**REZONING, PLANNED UNIT DEVELOPMENT  
& SUBDIVISION STAFF REPORT****Date: February 19, 2009****DEVELOPMENT NAME**

Roberts Brothers CPM

Providence/Coley Subdivision, Resubdivision of a portion of Lot 2

Subdivision Approval to create three lots of record from a metes and bounds parcel, Planned Unit Development Approval to allow sixteen apartment buildings and a clubhouse, twelve parking garages, and a maintenance building on a single building site, and Zoning Approval to rezone the proposed Lot 2 from R-1, Single-Family Residential District, to R-3, Multi-Family Residential District, to allow the construction of a 384-unit apartment complex. **It should be noted, however, that any use permitted in the proposed district would be allowed at this location if the zoning is changed. Furthermore, the Planning Commission may consider zoning classifications other than that sought by the applicant for this property.**

# SITE PLAN

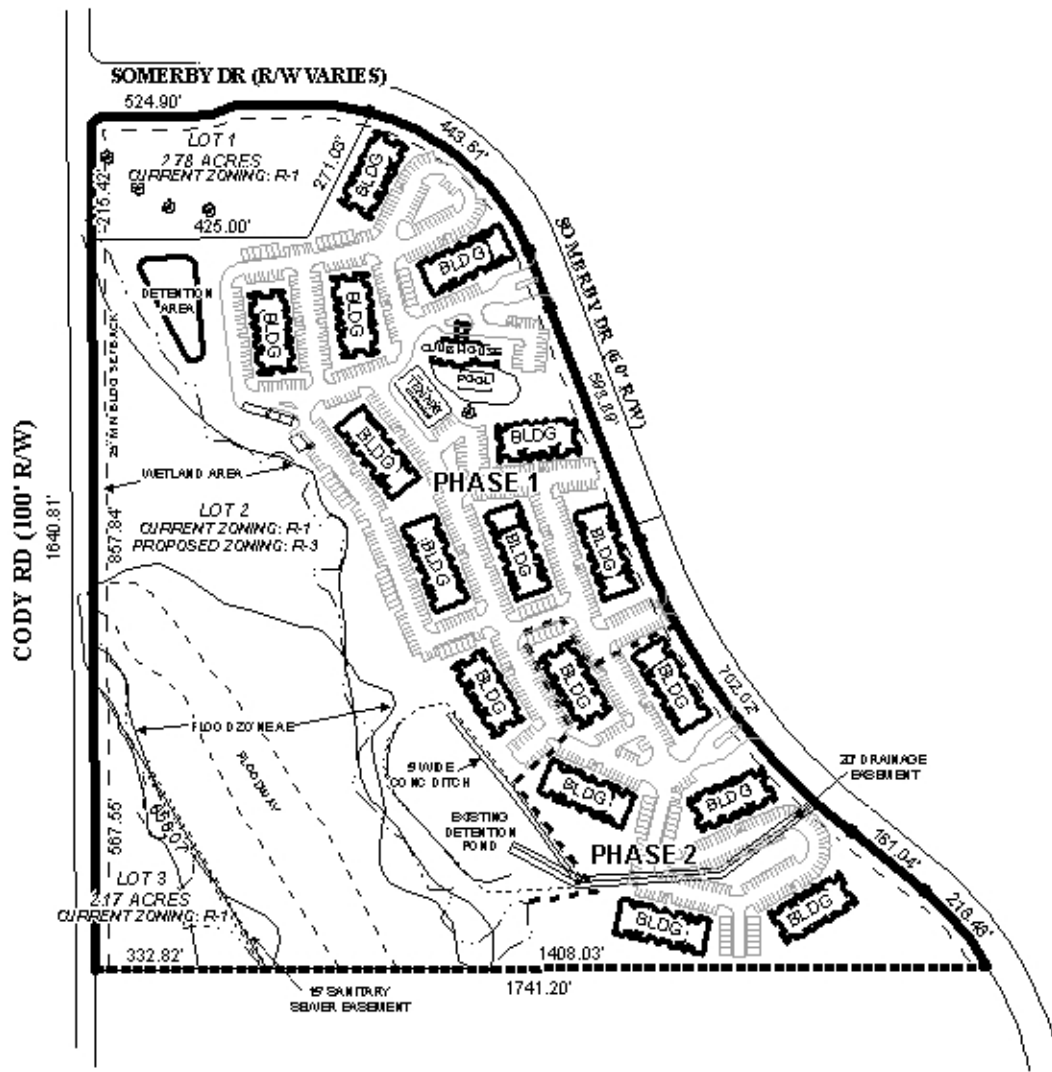
The site plan illustrates 16 apartment buildings (all 45' in height and ranging from 9,685 to 11,105 square feet), a club house (4,816 square feet), twelve parking garages (21,012 square feet), and a maintenance building (726 square feet). As illustrated, the development will be constructed in phases. Phase one consists of 240 dwelling units, the clubhouse, and 616 parking spaces, 42 of which are covered/garage parking spaces. Phase two consists of 144 units and 211 parking spaces, 30 of which are covered/garage parking spaces. While the site plan complies with the minimum landscaping requirements, there is no depiction of trees. The applicant should be aware that a Tree Plan, in compliance with Section 64-4.E.3 of the Zoning Ordinance, will be required at the time of permitting.

The applicant should revise the site plan to illustrate a buffer, in compliance with Section 64-4.D of the Zoning Ordinance, where the site abuts residentially zoned property. Furthermore, as required by Section 64-6.A.3.c of the Zoning Ordinance, any lighting for the parking lot shall be so arranged that the source of light does not shine directly into adjacent residential properties or into traffic.

Dumpster locations for the site are indicated on the site plan and in compliance with Section 64-4.D.9 of the Zoning Ordinance; however, the applicant should place a note on the site plan stating that dumpsters will be completely screened from view.

The applicant should also revise the site plan to provide a sidewalk along Somerby Drive and Cody Road.

Easements exist on the site; thus, a note should be placed on the plat / site plan stating that no development is allowed within any easement.

- 1) placement of a note on the site plan stating that Planned Unit Development is site plan specific; therefore any future changes (parking, structure expansion, etc.,) must be resubmitted for Planned Unit Development review, and be approved through the planning process;

- 2) provision of buffering, in compliance with Section 64-4.D of the Zoning Ordinance, where the site abuts residentially zoned property;
- 3) placement of a note on the site plan stating that lighting of parking facilities will comply with Section 64-6.A.3.c of the Zoning Ordinance;

- 4) placement of a note on the site plan stating that dumpsters will be completely screened from view;
- 5) provision of a sidewalk along Somerby Drive and Cody Road;

- 6) placement of a note on the site plan stating that no development is allowed within any easement;
- 7) placement of a note on the site plan stating that approval of all applicable Federal, state and local agencies is required for wetland issues, if any, prior to the issuance of any permits or land disturbance activities;

- 9) submission of a revised Planned Unit Development site plan to the Planning Section of Urban Development prior to the issuance of any permits or land disturbance activities;
